ADDENDUM NUMBER: One (1)

DATE: November 12, 2025

PROJECT: MONTGOMERY COUNTY EMS STATION 28

DESIGNER: DOUGLAS A. JONES, ARCHITECT
MONTGOMERY COUNTY ENGINEERING

E0.1

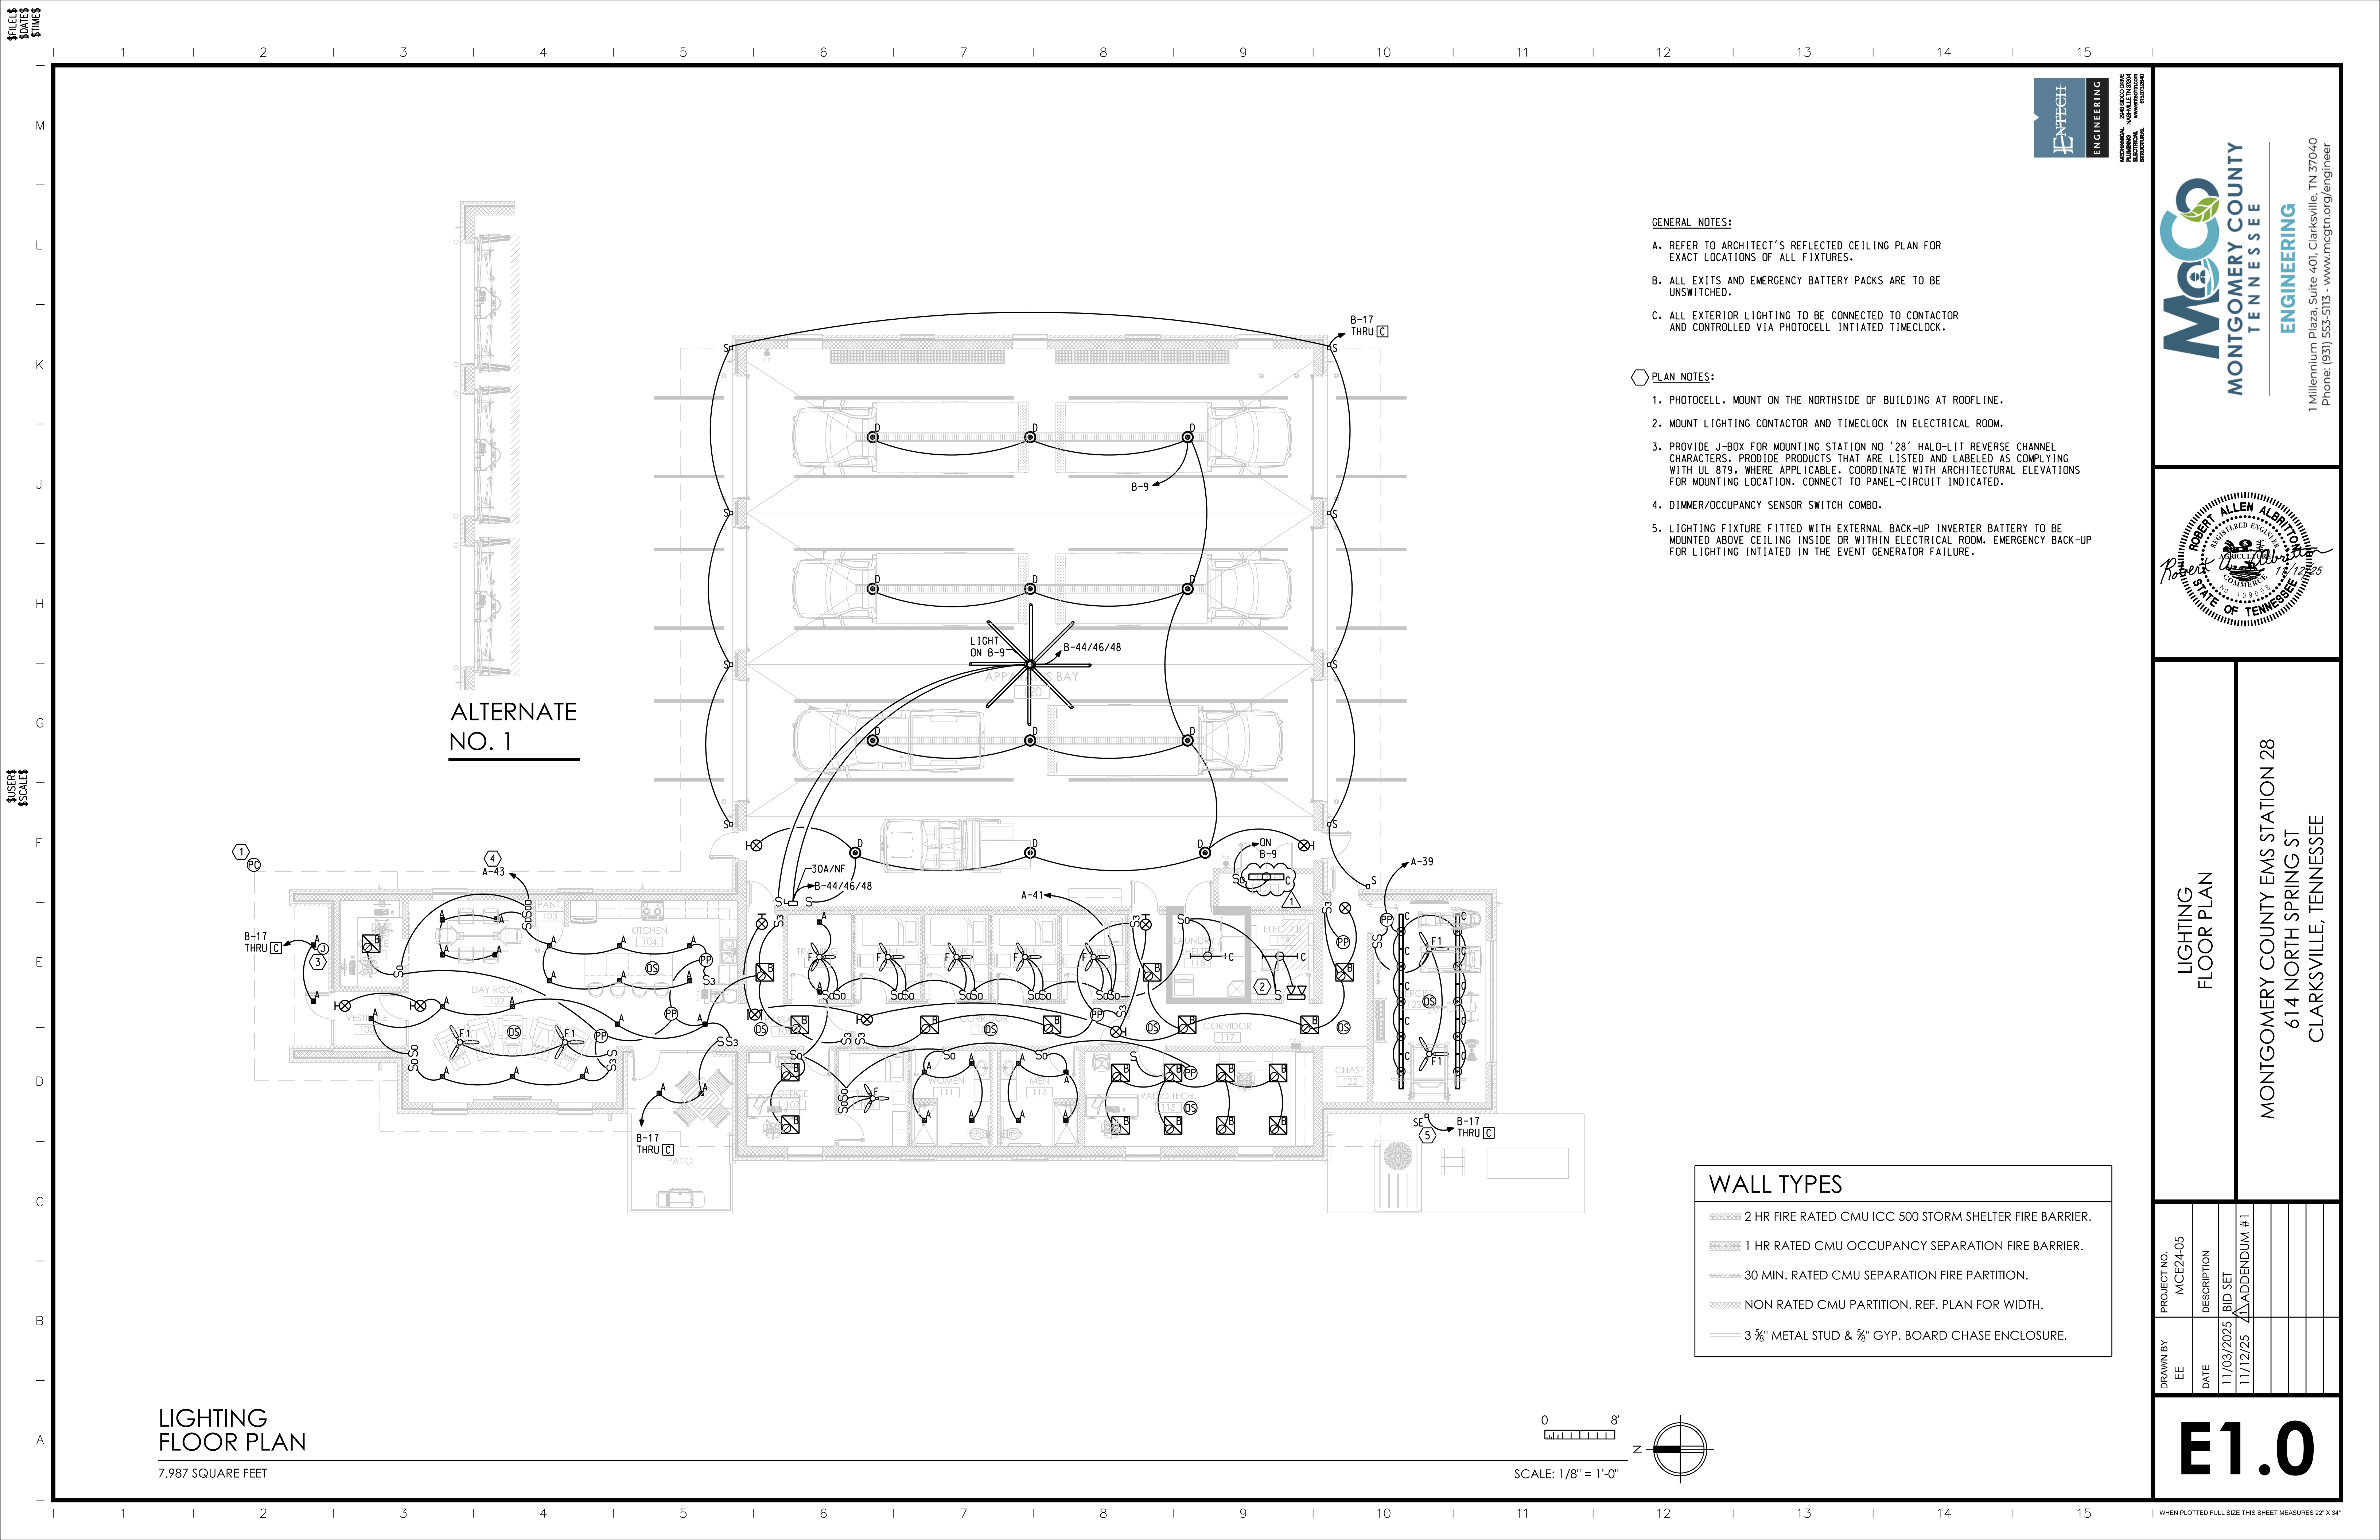
SHEET E0.1 - ELECTRICAL SITE PLAN; Delete Sheet E0.1 dated 11/03/2025 in its entirety. Substitute therefor: Sheet E0.1 - ELECTRICAL SITE PLAN dated 11/12/2025 attached hereto.

Clarification: Relocated service entrance equipment and ATS.

- Q:** Can the main disconnect be install beside the ATS in the back?
- A:** See new location shown on revised sheets E0.01 and E2.0.

E1.0

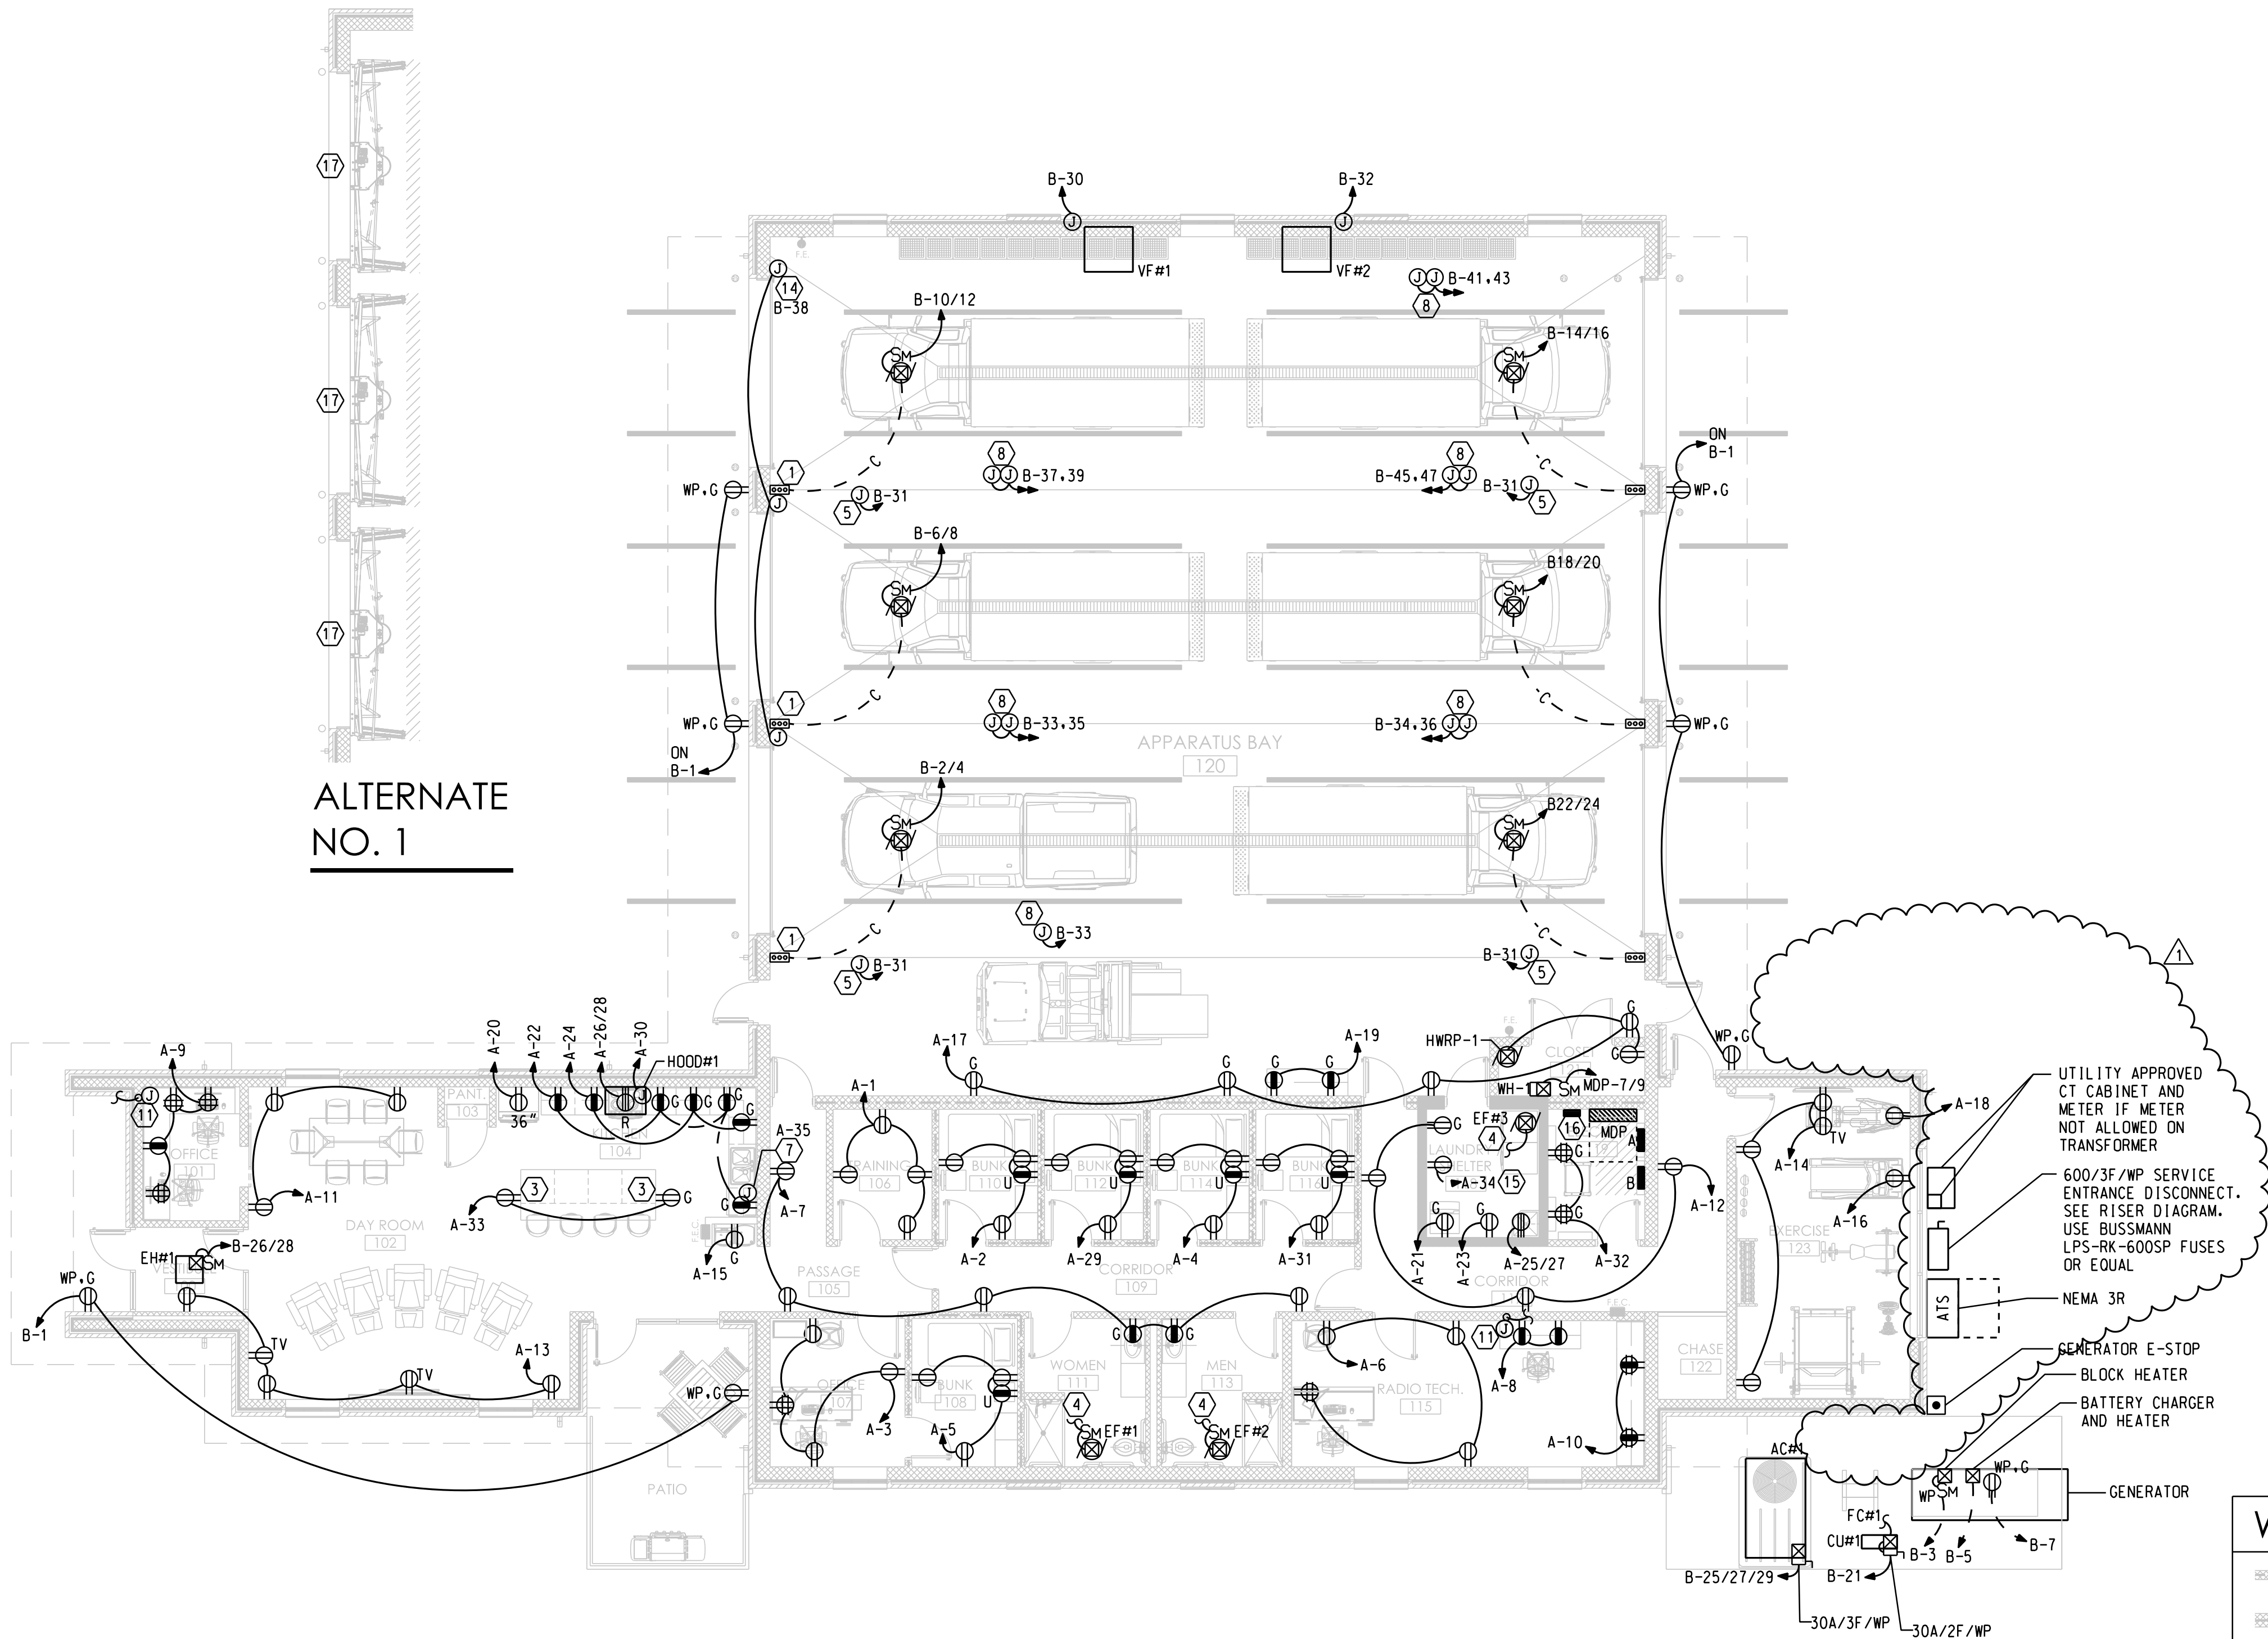
SHEET E1.0 - LIGHTING FLOOR PLAN; Delete Sheet E1.0 dated 11/03/2025 in its entirety. Substitute therefor: Sheet E1.0 - LIGHTING FLOOR PLAN dated 11/12/2025 attached hereto.

Clarification: Added lighting fixture label to light in closet 121.

- Q:** Closet 121 - what is the light in this room?
- A:** Type 'C' fixture will be used in this room. See revised sheet E1.0.
- Q:** Who will supply the big fan in the bay? if electrical Will we need info on what is to be supplied.

E2.0

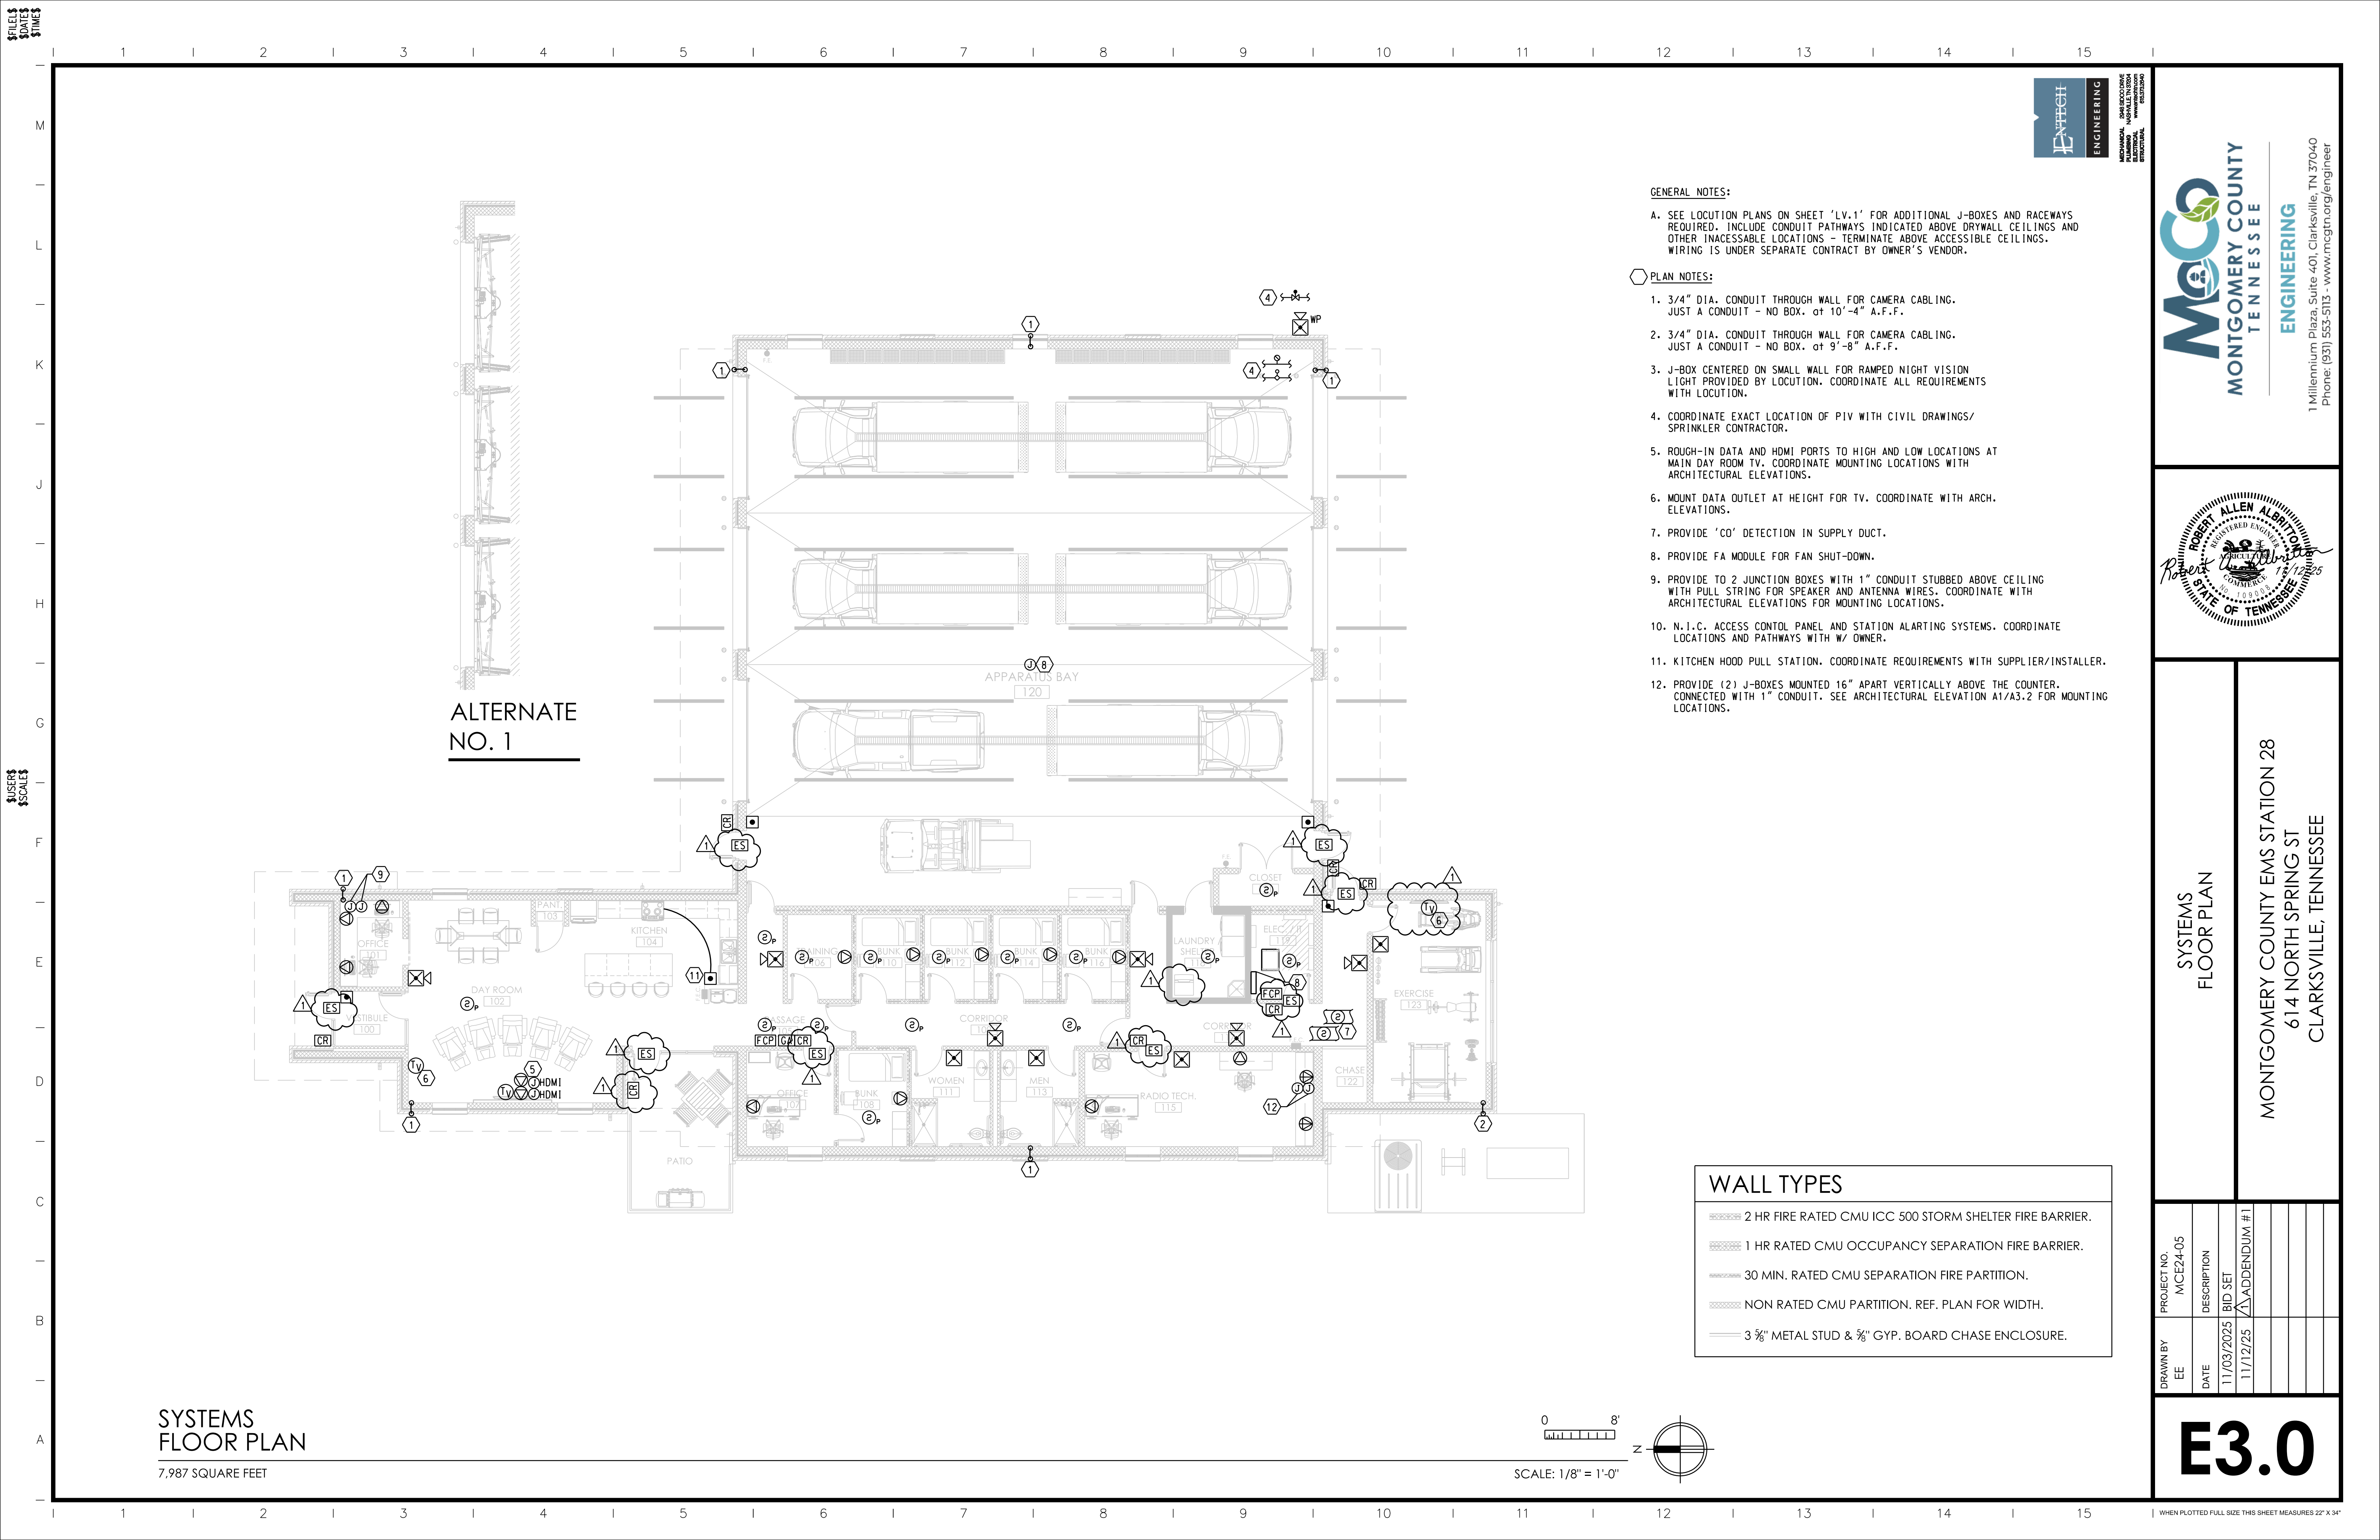
SHEET E2.0 - POWER FLOOR PLAN; Delete Sheet E2.0 dated 11/03/2025 in its entirety. Substitute therefor: Sheet E2.0 - POWER FLOOR PLAN dated 11/12/2025 attached hereto.

Clarification: Relocated service entrance equipment and ATS.
